THE NEW MILL

Ref New Mill Restaurant Planning Consent F/2001/3329

New Mill Restaurant
Finchampstead
Compensation
Volume Calculations

REQUEST FOR FURTHER INFORMATION: FLOOD COMPENSATION CALCULATIONS AND CONFIRMATION OF OUTCOME OF MEETING RE:DISCHARGE OF FLOOD COMPENSATION CONDITION

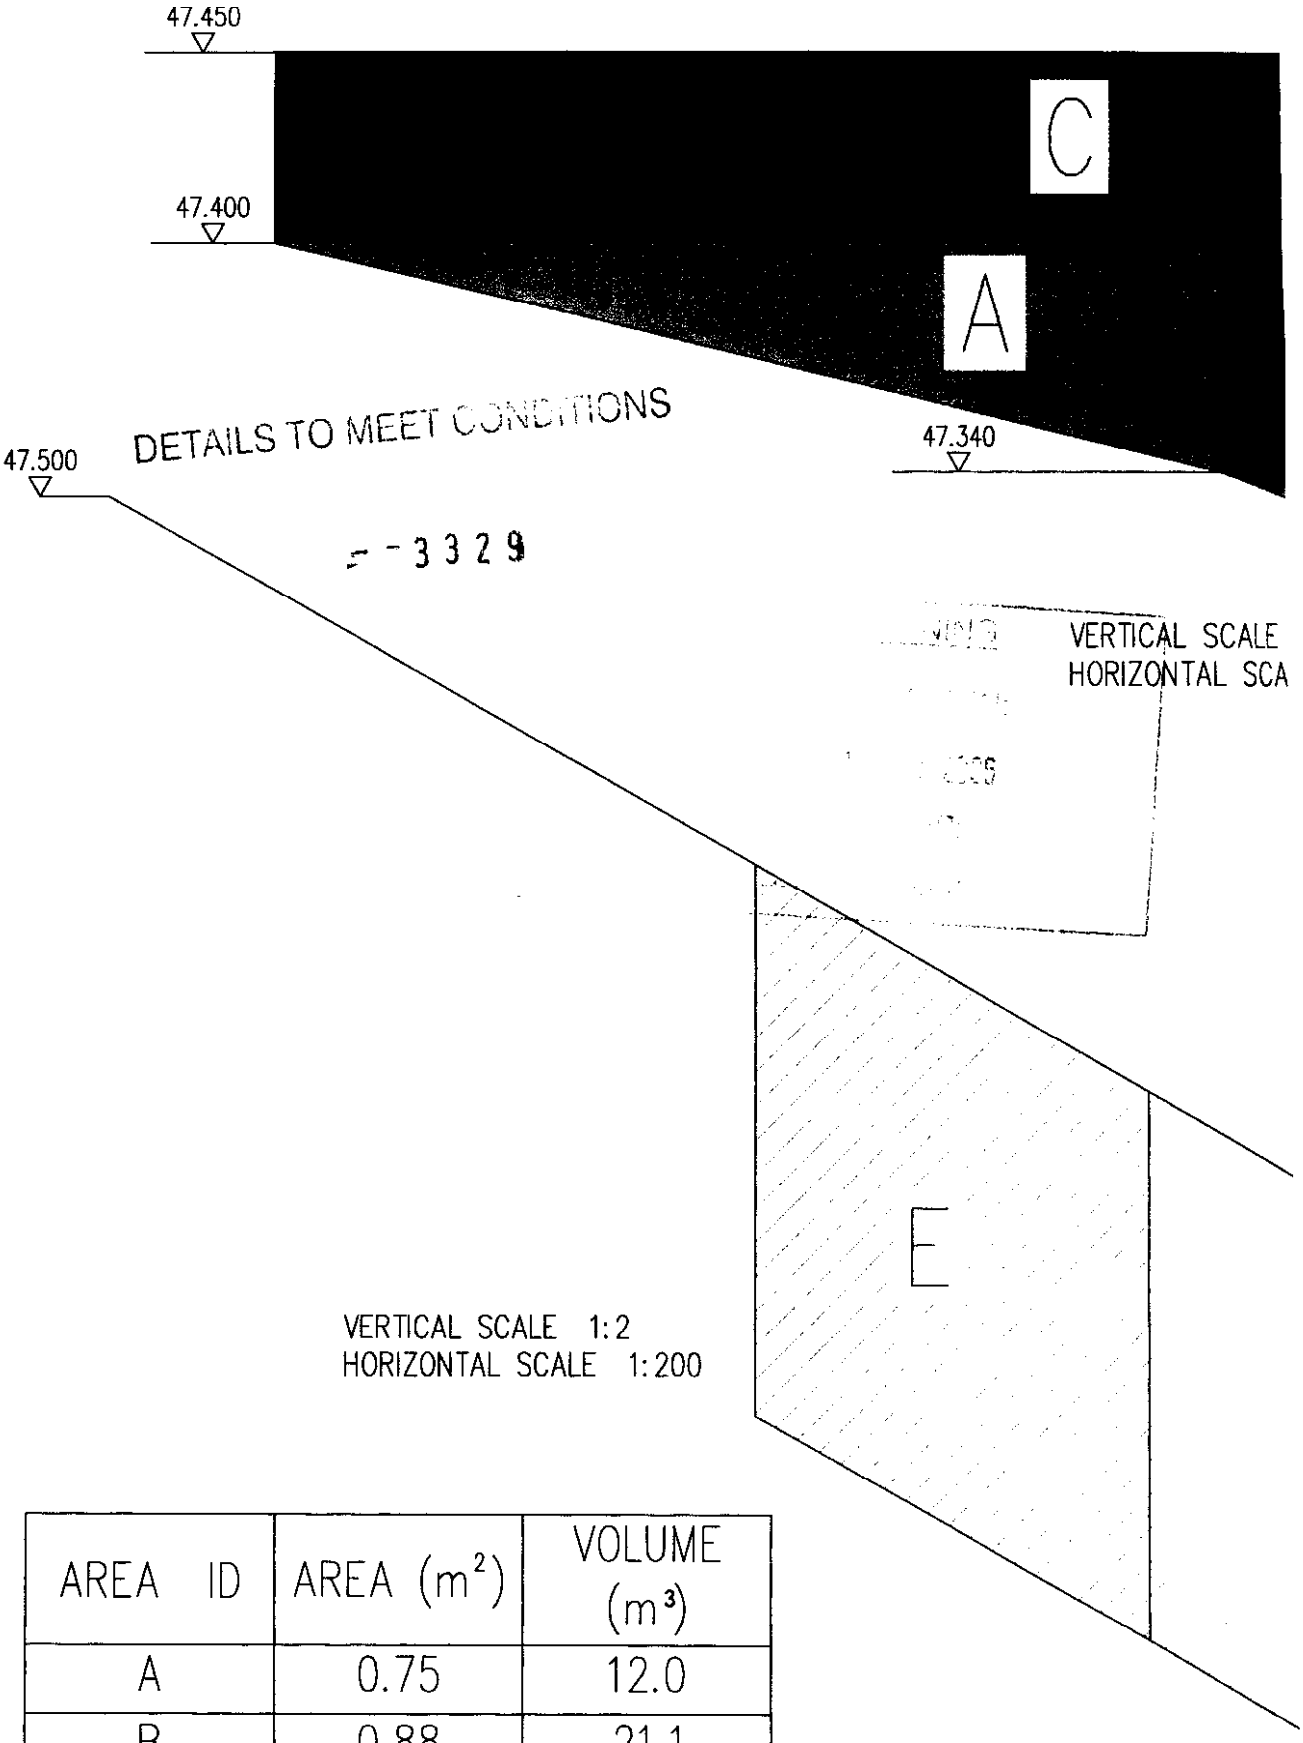
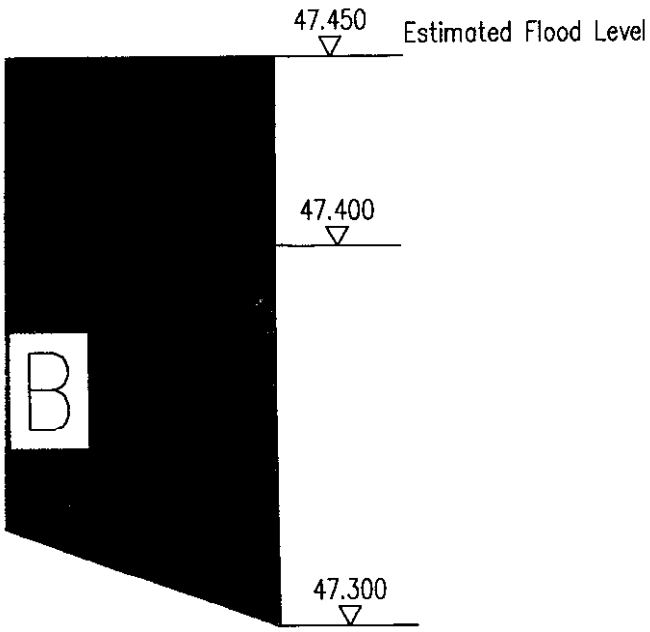
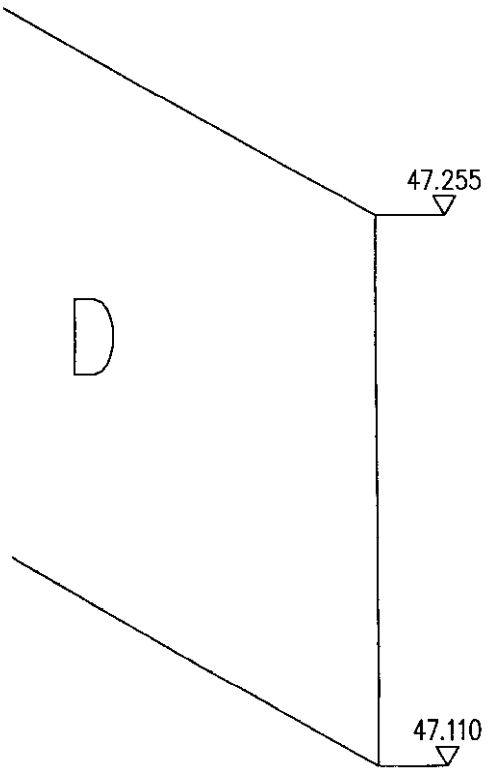
We have attended a site meeting on 28th December 2005 and have reviewed plans (16943/001/001 and 629/2A) on the work provided by the developer and/or their consultants, which we understand, are provided to discharge the terms of the condition. We are reliant on the accuracy and completeness of these reports in undertaking our review, and can take no responsibility for incorrect data or interpretation made by the authors. Based upon these reports, we can confirm that the EA considers that the work carried out at the site meets the requirements of the condition proposed by the agency.

OUTLINE PLANTING SCHEME FOR NEW MILL, NEW MILL ROAD, EVERSLEY

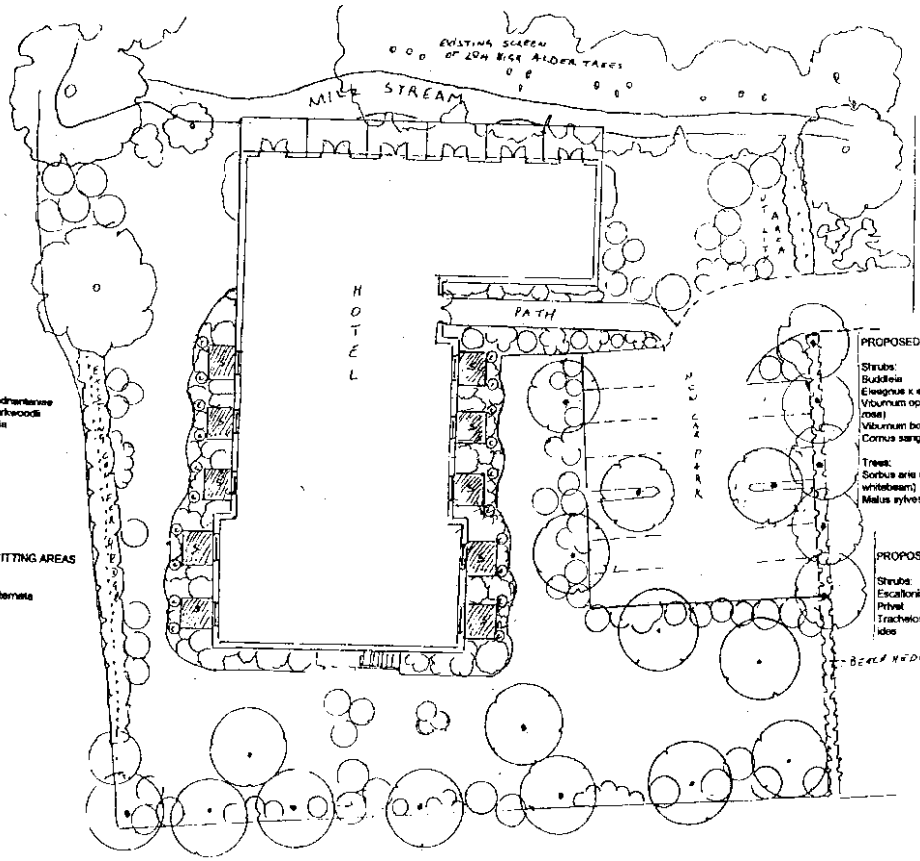
Tree Protection
No tree protection measures have been shown on the plan. We require for approval detail proposals showing the location and form of protective fencing in accordance with BS 5837: 1991 – Trees in Relation to Construction.

Proposed Planting
The current proposals are insufficient whist I note that these are outline if they are being submitted to clear the planning conditions we should require the following:

We also require for approval information on topsoil depths, cultivation and quality, notes on planting techniques, mulch, grass cover and maintenance specification.

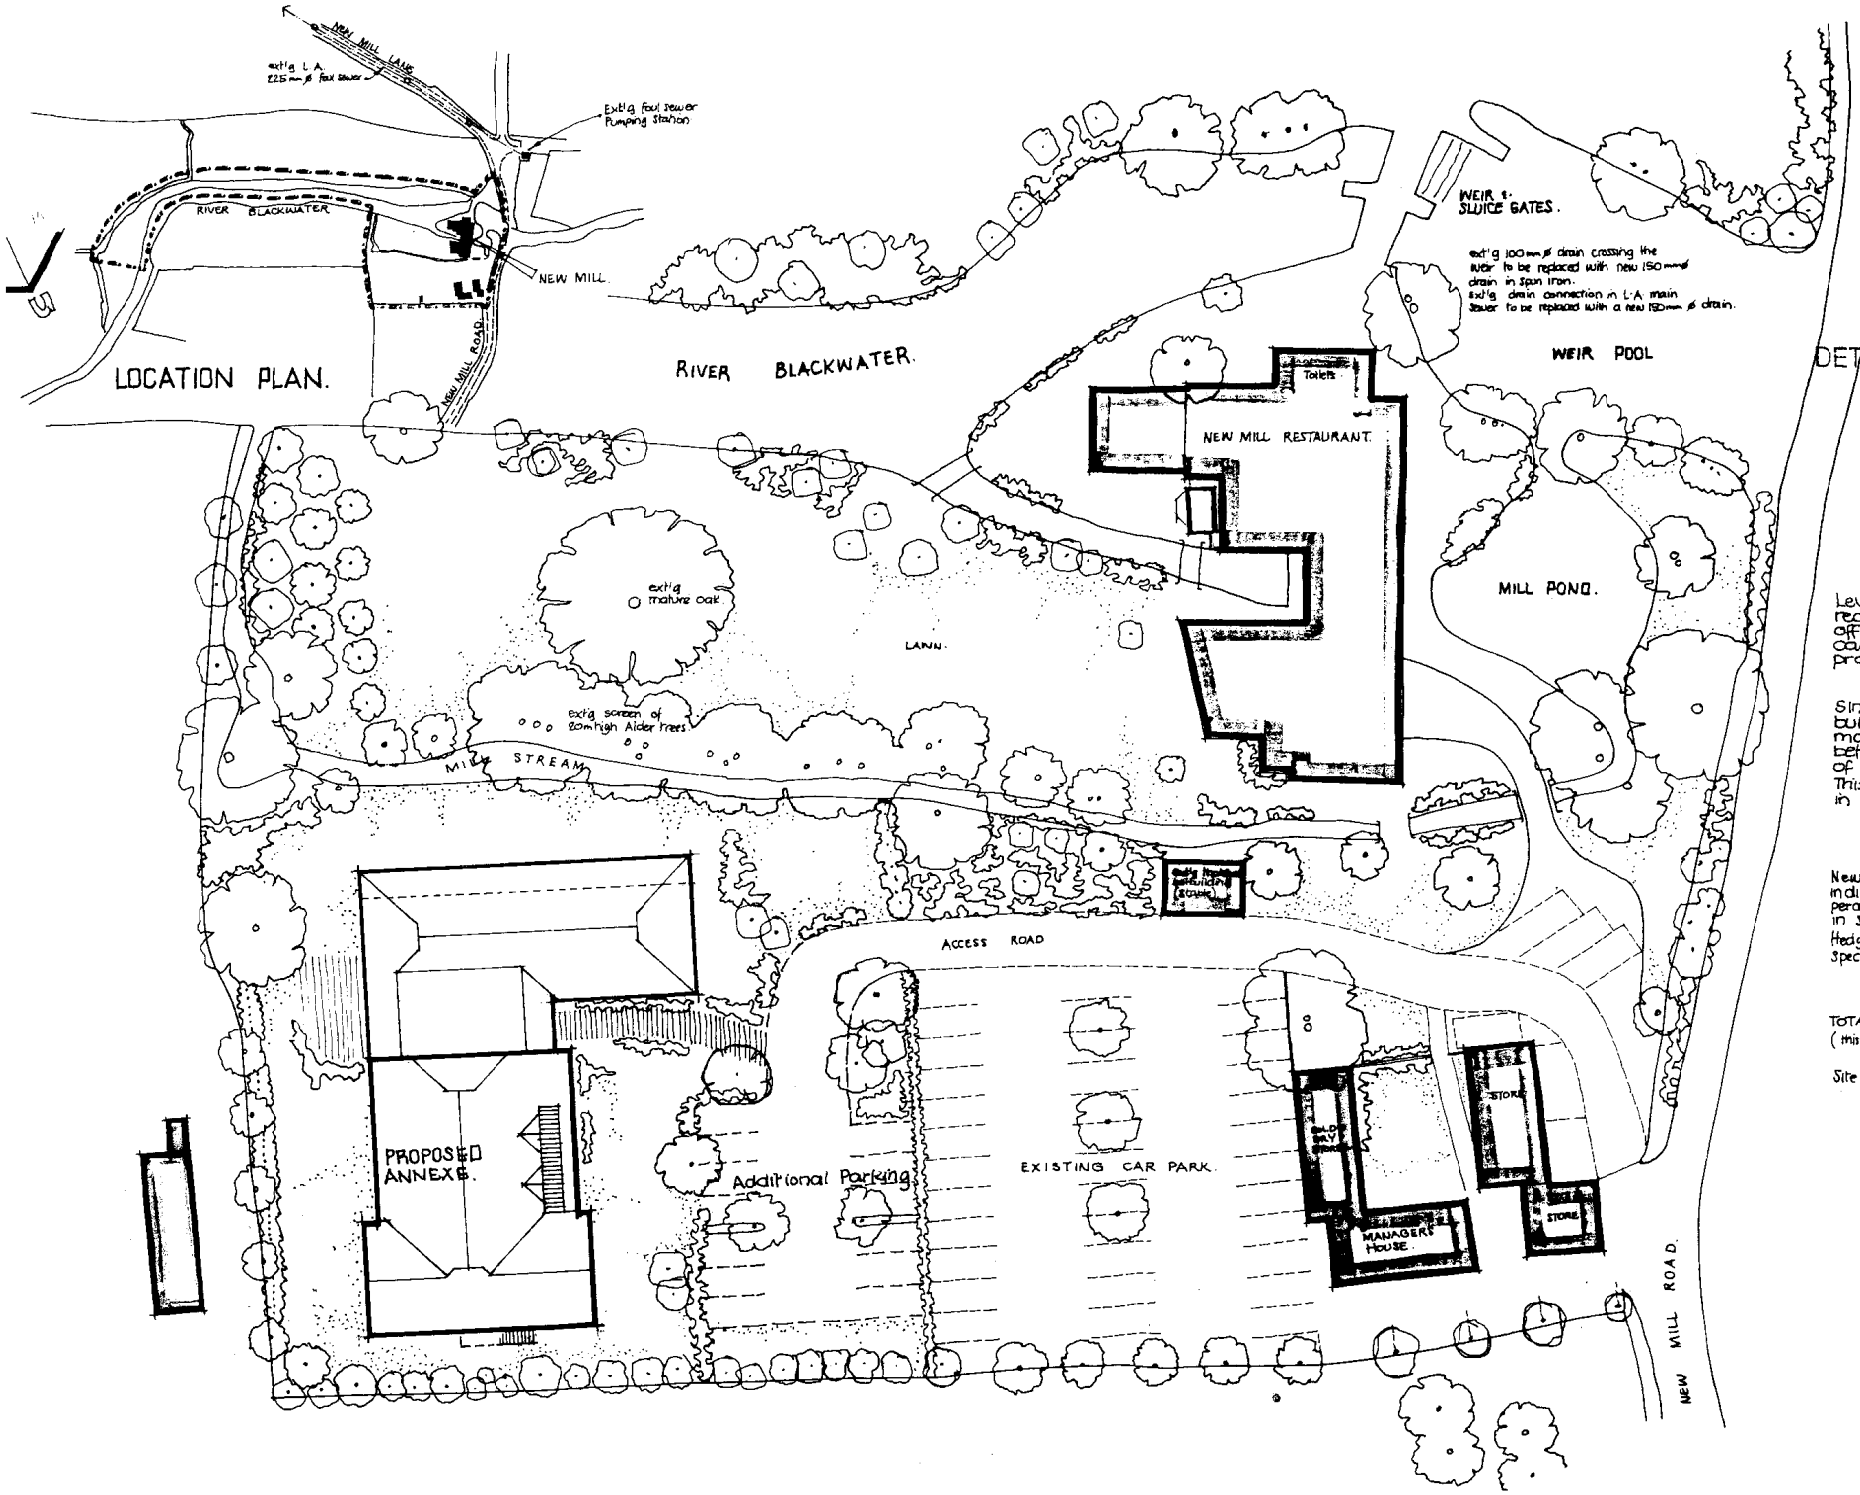
Condition 3 & 14: (Can be considered together)
As we have said in previous correspondence, we only accept level-for-level flood plain compensation. The statement they have made about lowering the carpark is not sufficient. They would need to provide calculations and proposed levels in the compensation area to show that sufficient compensation was being provided. As there is no 1 in 100 year flood level available for this area (to my knowledge), they would probably need to discuss it with our DC engineer to agree a level to work to. Also the raising of the building on piers is not considered to be floodplain compensation by the Environment Agency.

"Single storey section of proposed building to be raised on piers to maintain a height of 300mm between ground level and the underside of the ground floor construction" and "Levels of new car parking area to be reduced by an appropriate figure to offset floodwater displacement caused by single storey section of proposed building". On the latter point I assume we need to know the proposed level for the car park. In addition, would this then be sufficient to discharge condition 3? And, is condition 14 part of condition3?

Levels of new car parking area to be reduced by an appropriate figure to offset flood water displacement caused by 2 storey section of proposed building.

Single storey section of proposed building to be raised on piers to maintain a clear height of 300 mm between ground level and the underside of the ground floor construction. This to allow free passage of water in time of serious flooding.
